| DOCKETED | |
|-------------------------|--|
| Project Title: | Martin Backup Generating Facility (MBGF) |
| Document Title: | Martin Properties Responses to Data Request Set 2 - MBGF |

RESPONSE TO CEC STAFF DATA REQUEST SET 2 (1-11)

Martin Backup Generating Facility (22-SPPE-03)

Revised Civil Plan – Truck Entrance Modifications

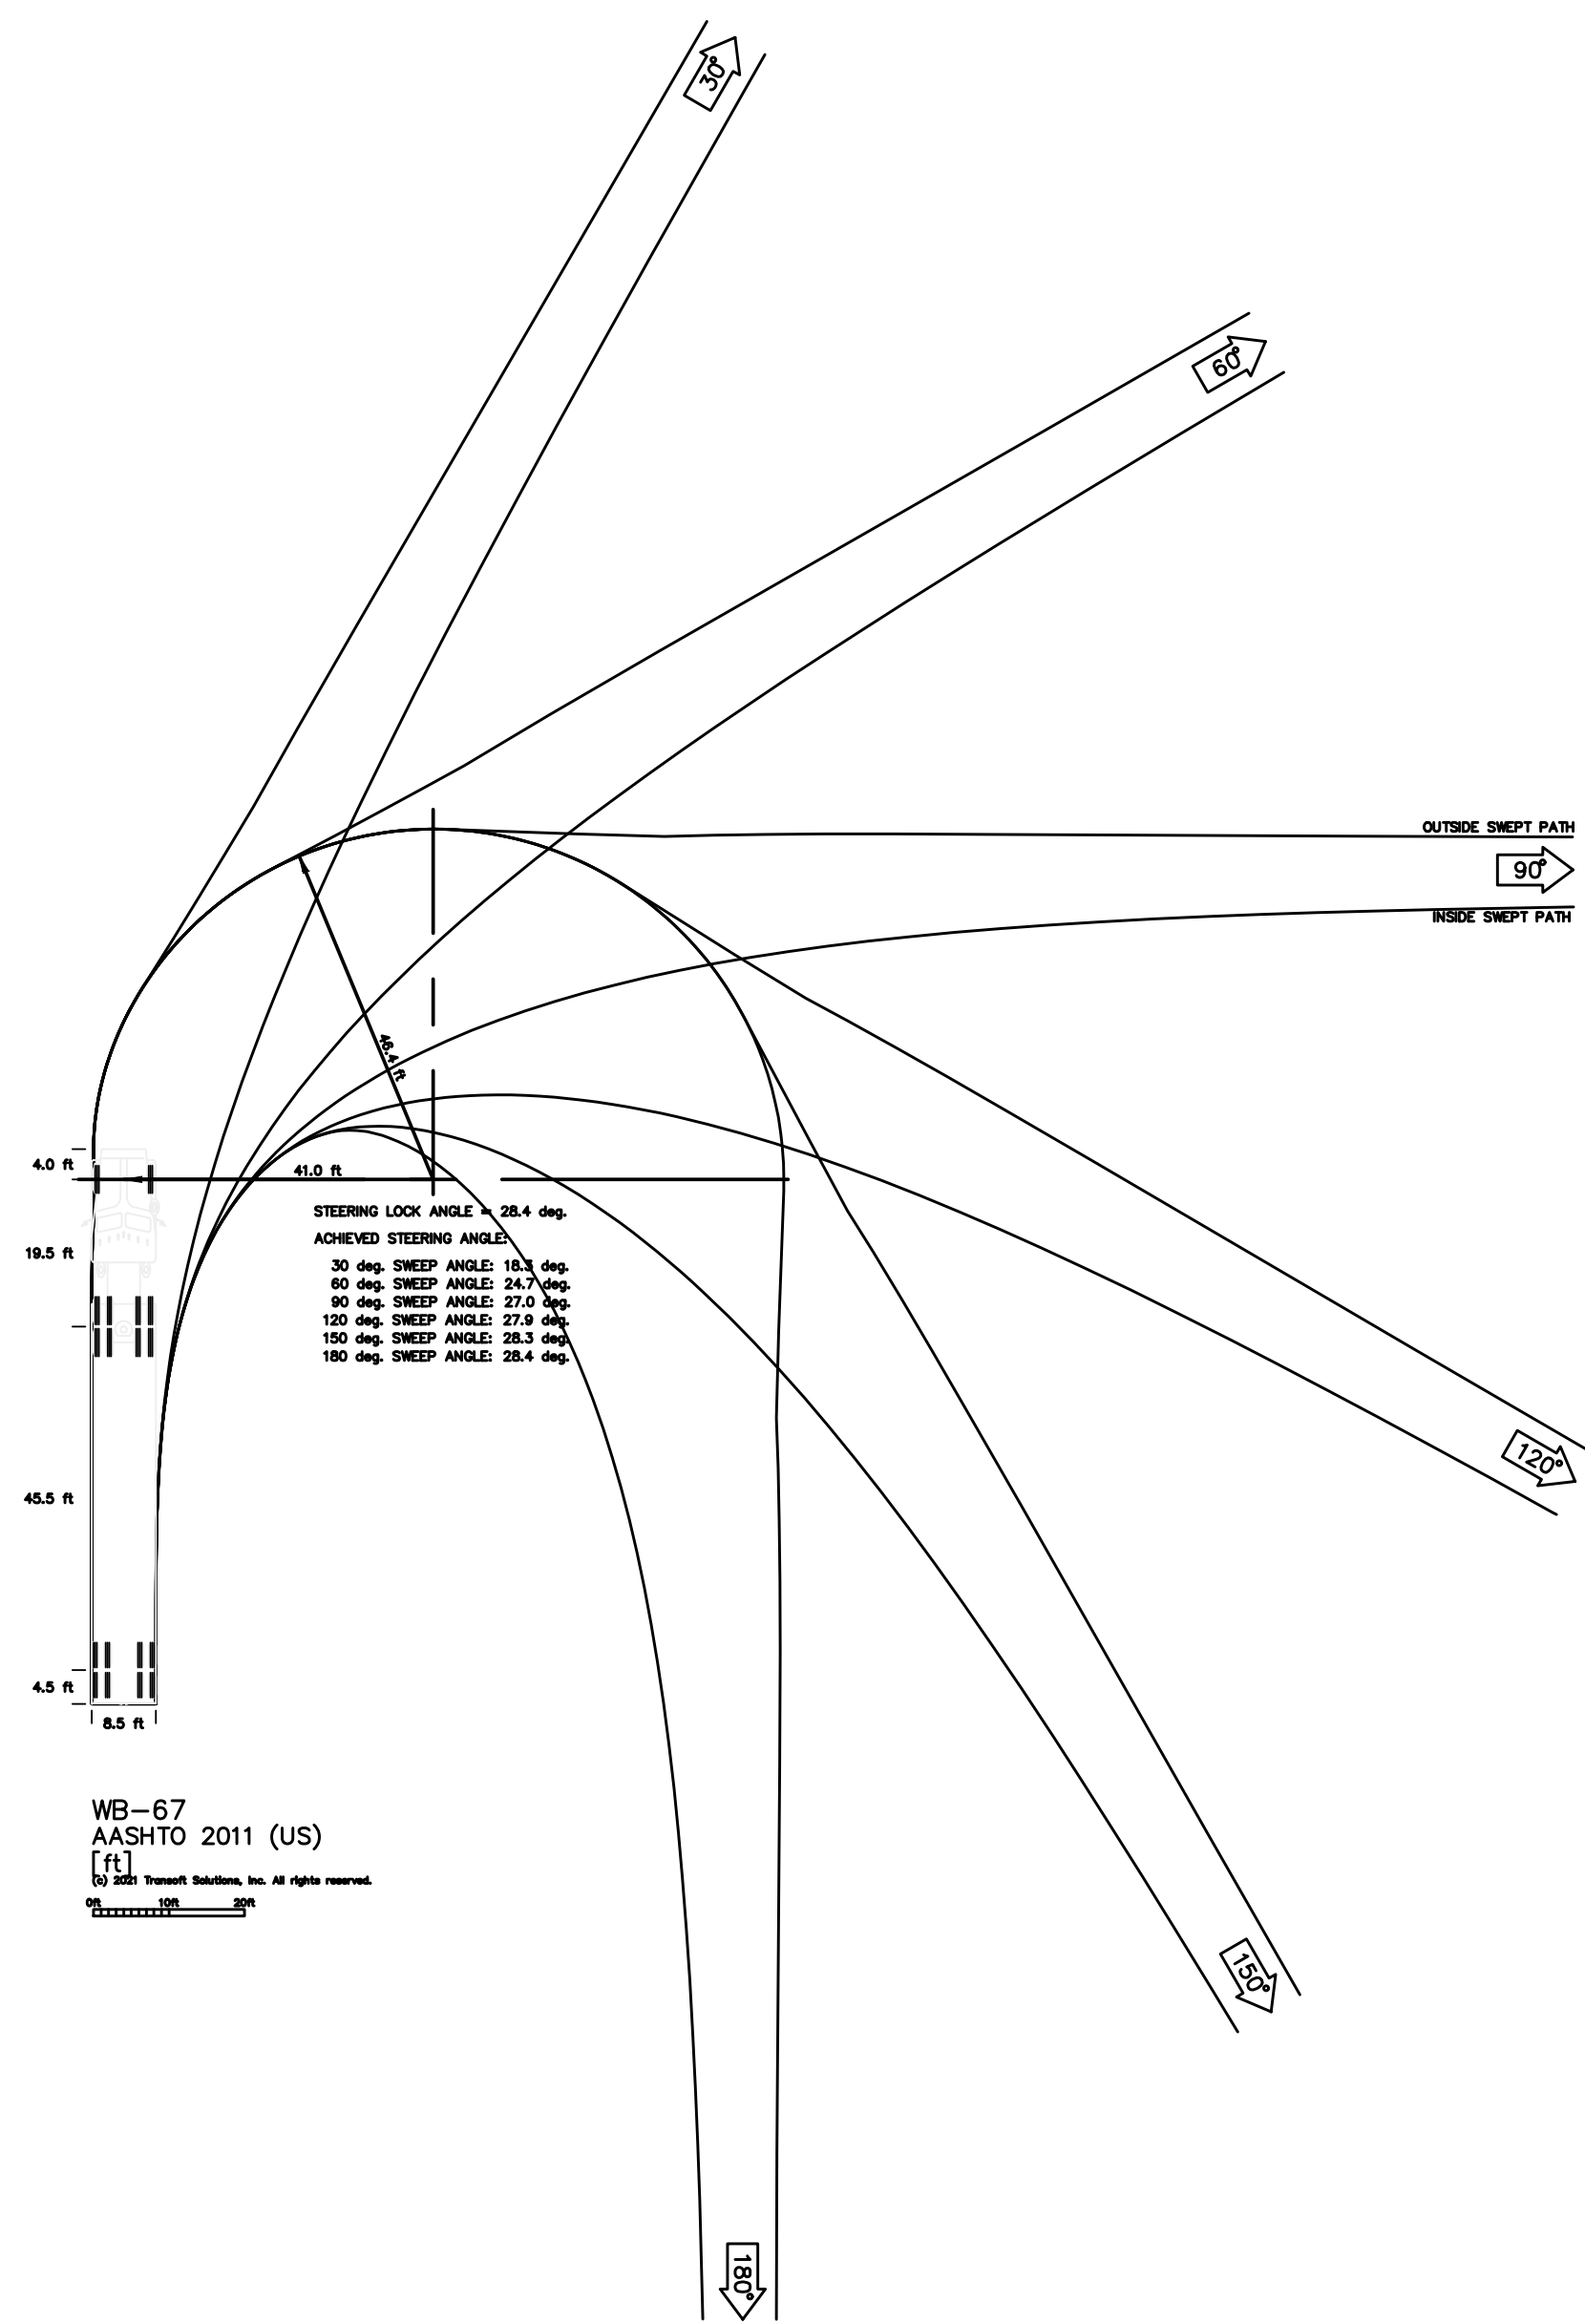
7. Please confirm the purpose of the 16-foot-wide center driveway on Martin Avenue shown on site plans as well as the type of vehicle access control (e.g., gate) to be installed in this location and, if applicable, truck turning movements for access to and from this driveway. This driveway is noted on site plans but excluded from project narratives and no truck turning movements are shown for this driveway.

The purpose of this driveway is to provide access to the SVP substation. The Civil Plan has been revised (See Appendix TRANS DR-7) as follows:

- Shifted the island in the east driveway to accommodate truck manoeuvres.
- The center drive aisle (into the substation) has been revised per the PCC comment stating it cannot be a curb return entrance and is to be CSC standard apron driveway entry.

Please see updated sheet C7 illustrating the revised truck manoeuvring for the east side driveway to be more than 10.0' clear from the south side of Martin Avenue. The 2018 Santa Clara Bicycle Master Plan illustrates a "future Class IV bike lane" along Martin Ave. Currently, the existing condition allows for stopping/parking for vehicles less than 20.0' long along our project frontage. The assumption is that if/when the future Class IV bicycle lane (which would be 10.0' wide – 7.0' wide lane with 3.0' wide separator) is installed, then the existing parallel parking along project frontage would be removed.

1 ARCHITECTURAL SITE PLAN
3/164" = 1'-0"

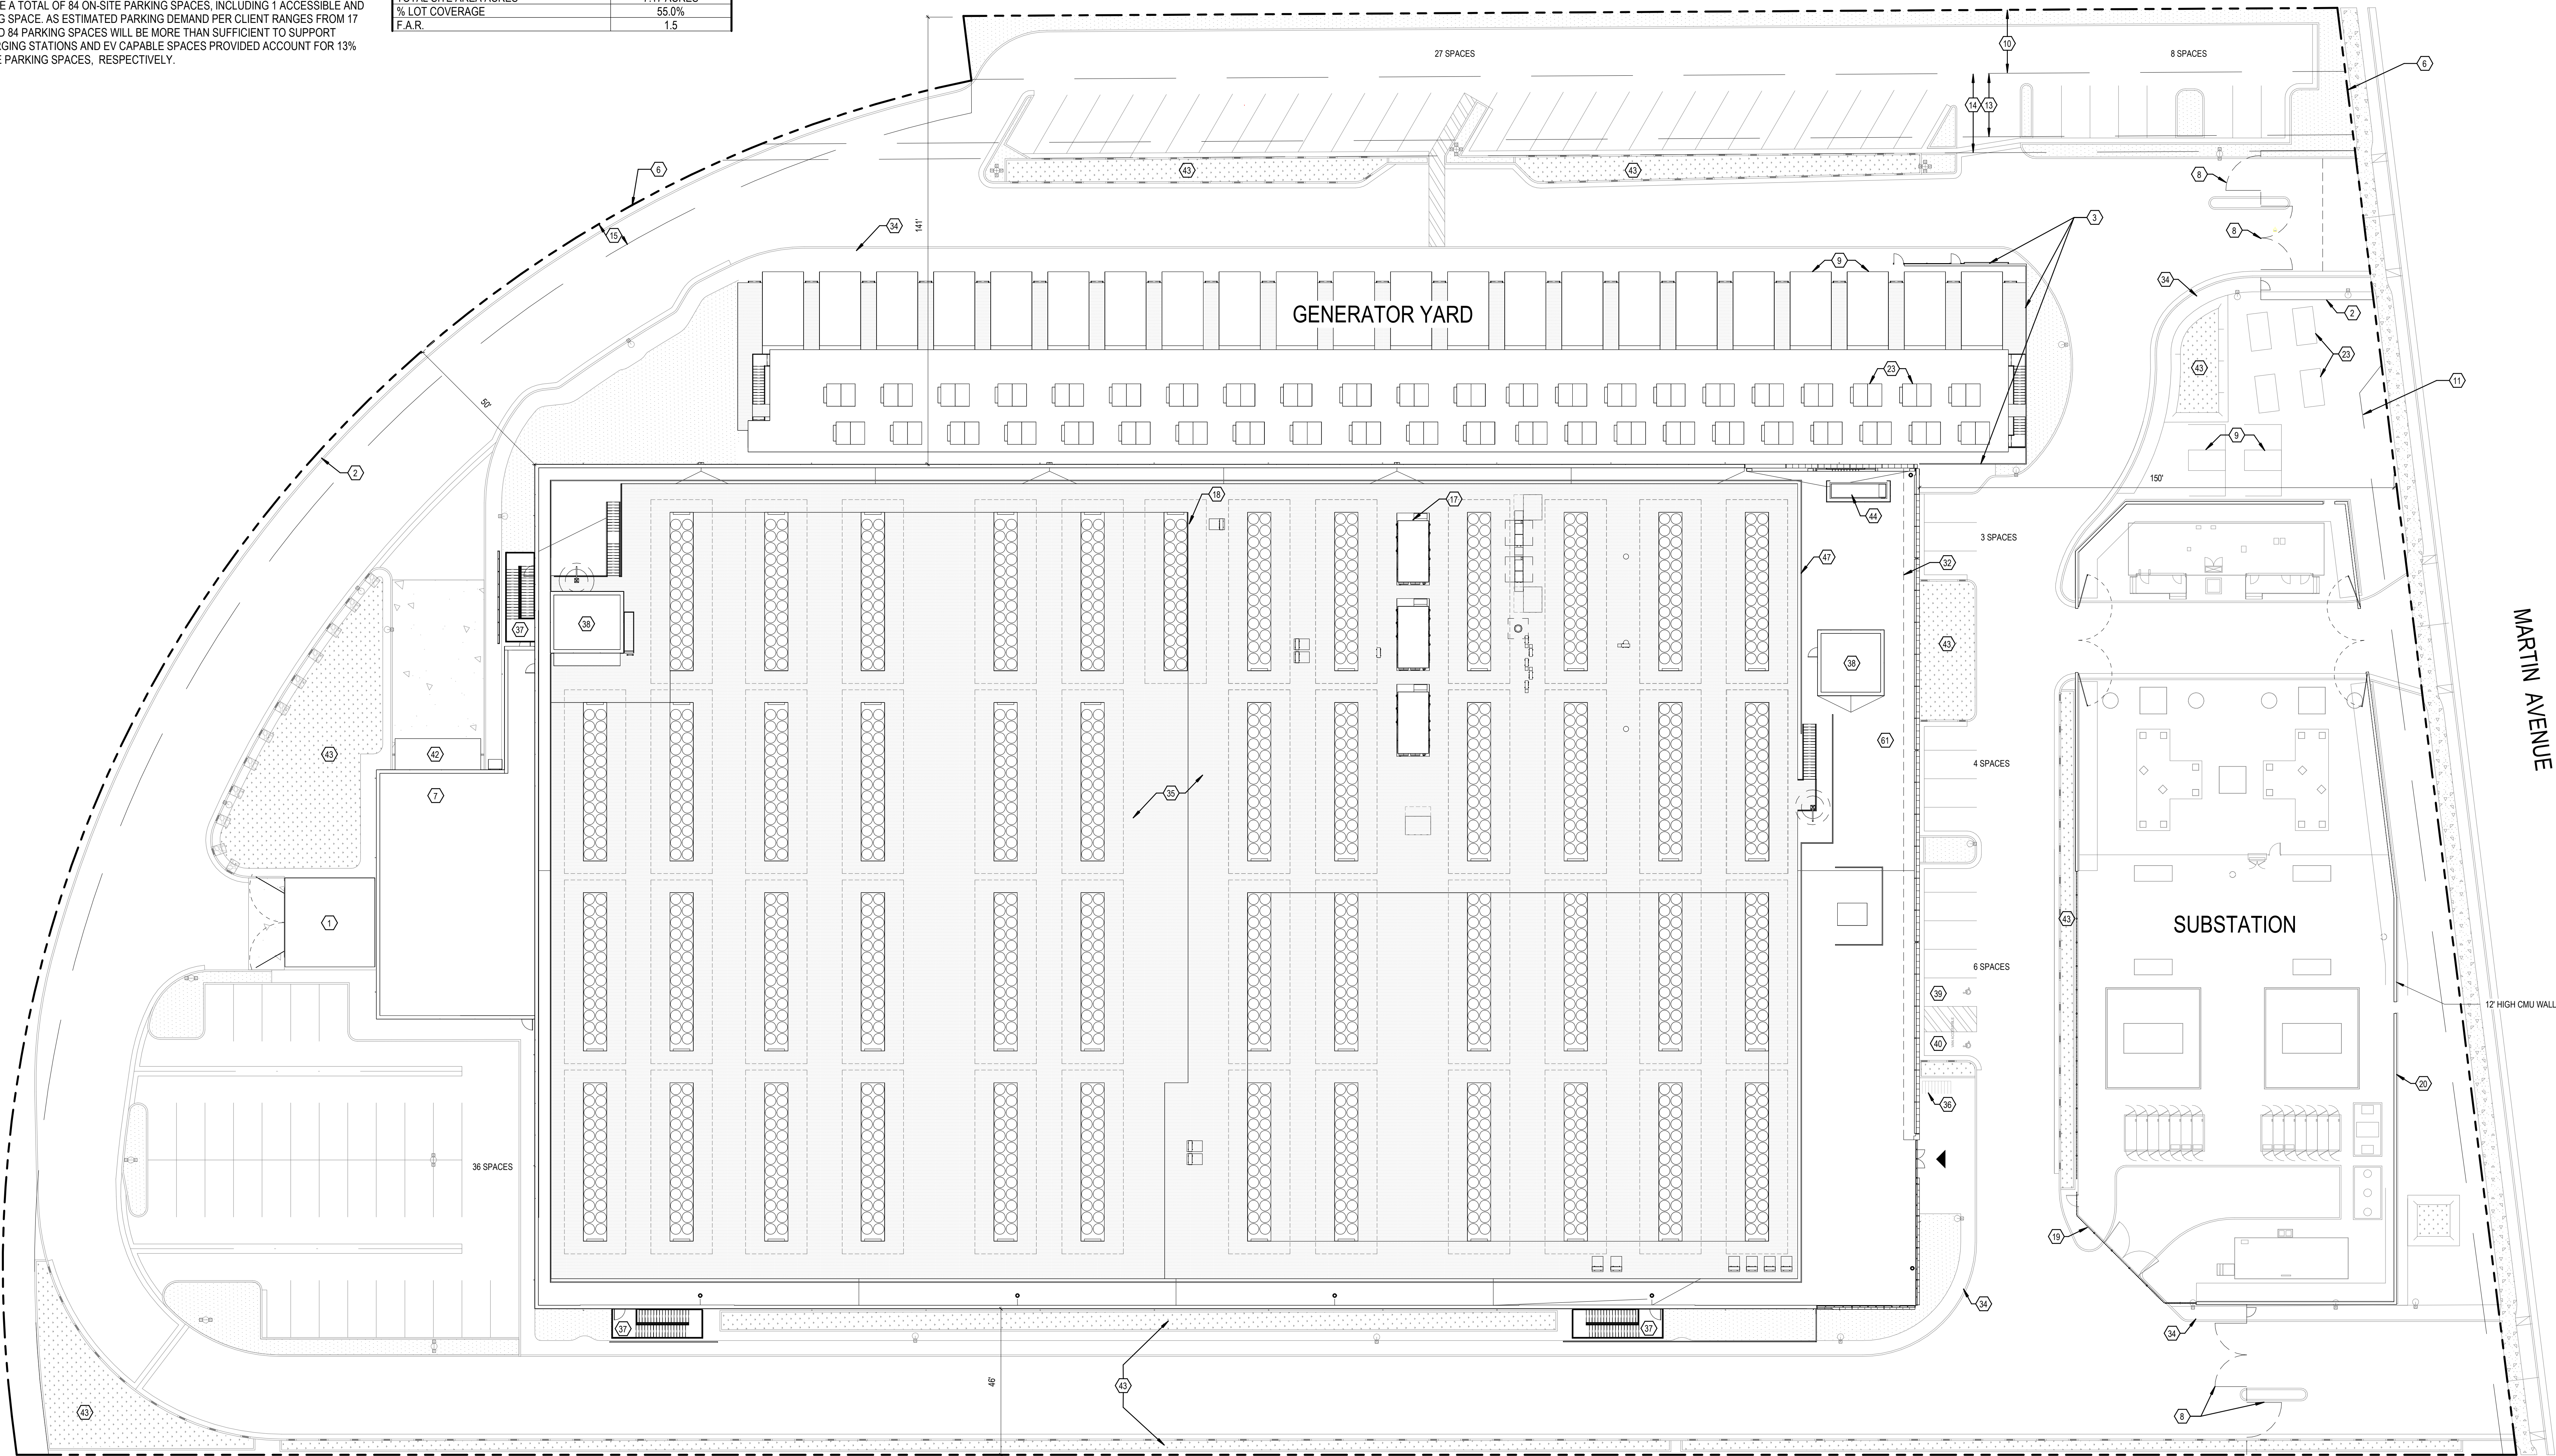
8. Please confirm the number of vehicle parking spaces on site. The SPPE application mentions 92, yet only 87 are included on the site plan. Please also indicate the number of accessible parking spaces if this differs from the one regular accessible space and one van accessible space shown on the site plan.

The project will provide a total of 84 on-site parking spaces, including 1 accessible and 1 van accessible parking space. As estimated parking demand per Client ranges from 17 to 30 vehicles, the proposed 84 parking spaces will be more than sufficient to support operations.

THE PROJECT WILL PROVIDE A TOTAL OF 84 ON-SITE PARKING SPACES, INCLUDING 1 ACCESSIBLE AND 1 VAN ACCESSIBLE PARKING SPACE. AS ESTIMATED PARKING DEMAND PER CLIENT RANGES FROM 17 TO 30 VEHICLES, PROPOSED 84 PARKING SPACES WILL BE MORE THAN SUFFICIENT TO SUPPORT OPERATIONS. THE EV CHARGING STATIONS AND EV CAPABLE SPACES PROVIDED ACCOUNT FOR 13% AND 20% OF TOTAL ON-SITE PARKING SPACES, RESPECTIVELY.
